BENTLEY RIDGE SUBDIVISION

APPLICATION NUMBER 7 DATE July 17, 2014

REQUEST Subdivision

DETAIL SITE PLAN

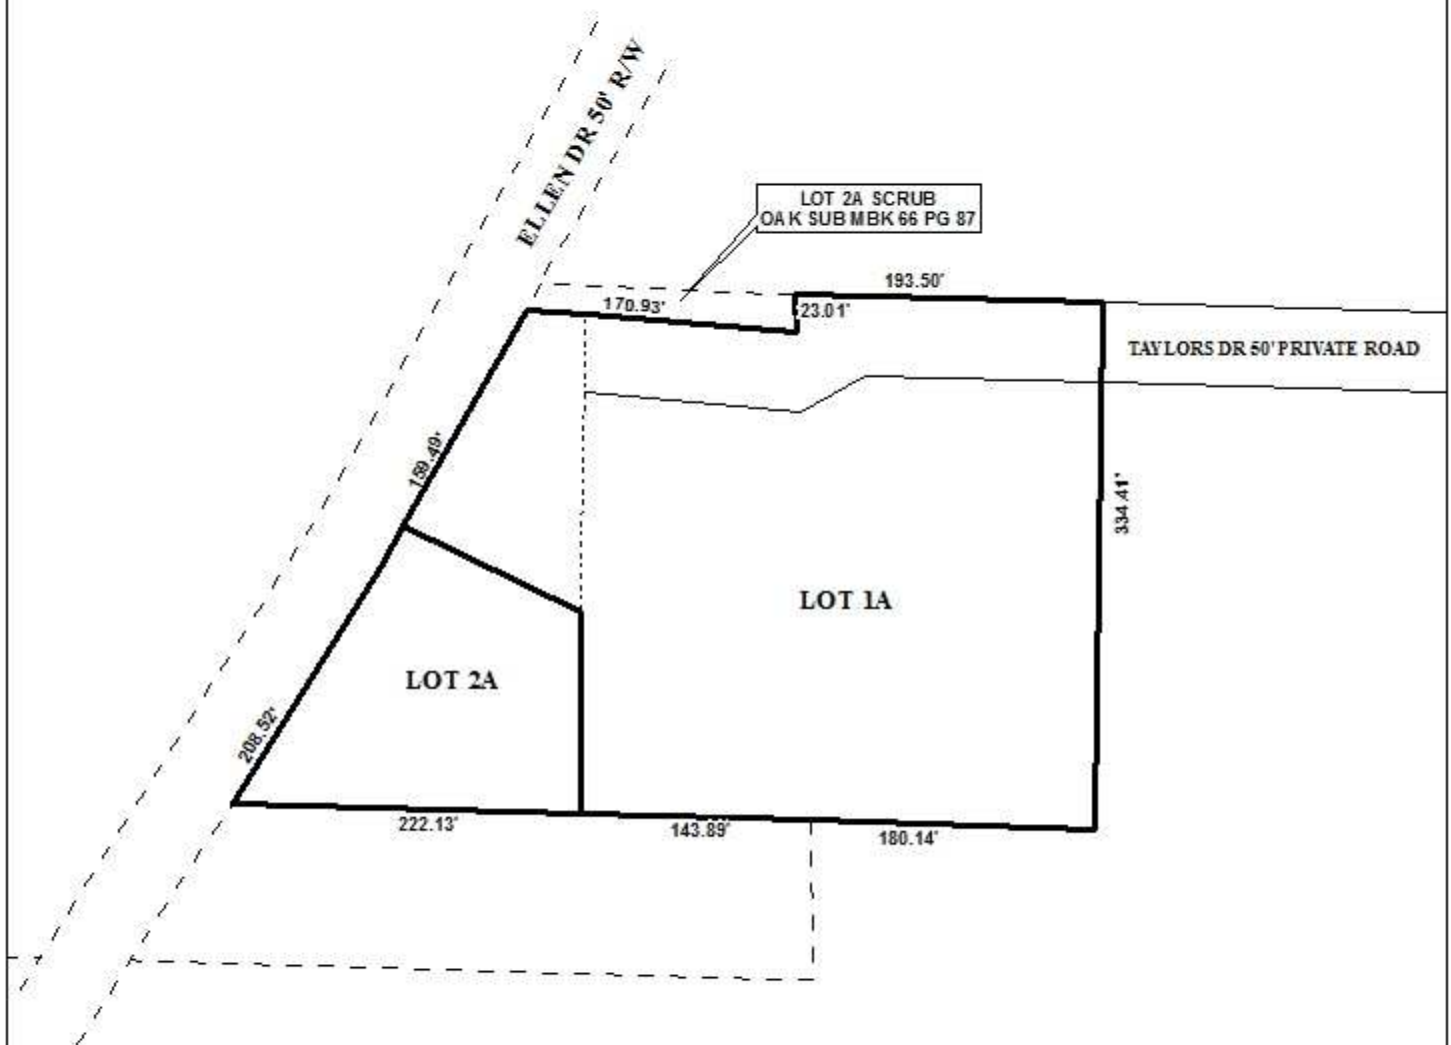
Both lots would have frontage on Ellen Drive, a minor street with a current 50' right-of-way width and without curb and gutter. As the Subdivision Regulations require a 60' right-of-way width for such, dedication would be required to provide 30' from the centerline of Ellen Drive. Lot 1A would also have frontage on Taylor's Drive, a private road which was recorded with Taylor's East Ridge Subdivision, with a 50' right-of-way. As a means of access management, a note should be required on the Final Plat stating that each lot is limited to one curb cut to Ellen Drive, with the size, design and location to be approved by County Engineering and conform to AASHTO standards. Lot 1A should also be limited to the existing curb cut to Taylor's Drive, in compliance with County Engineering requirements.

No minimum building setback line is indicated on the plat. Therefore, the plat should be revised to indicate a 25' minimum building setback line along Ellen Drive for both lots, as measured from any required dedication. The plat should be revised to also indicate a 25' minimum building setback line along Taylor's Drive for Lot 1A.

The proposed lots meet the minimum size requirements of the Subdivision Regulations; however, the lots are not labeled with their sizes on the preliminary plat. Therefore, the plat should be revised to label the lots with their sizes in square feet and acres, after any required dedication, or a table should be furnished on the Final Plat providing the same information.

- 1) dedication to provide 30' from the centerline of Ellen Drive;
- 2) placement of a note on the Final Plat stating that each lot is limited to the existing curb cut to Ellen Drive, with the size, design and location to be approved by County Engineering and conform to AASHTO standards;
- 3) placement of a note on the Final Plat stating that Lot 1A is limited to one curb cut to Taylor's Drive, in compliance with County Engineering requirements;
- 4) revision of the plat to indicate a 25' minimum building setback line along Ellen Drive for both lots, as measured from any required dedication;

- 5) revision of the plat to indicate a 25' minimum building setback line along Taylor's Drive for Lot 1A;
- 6) revision of the plat to label the lots with their sizes in square feet and acres, or the furnishing of a table on the Final Plat providing the same information;
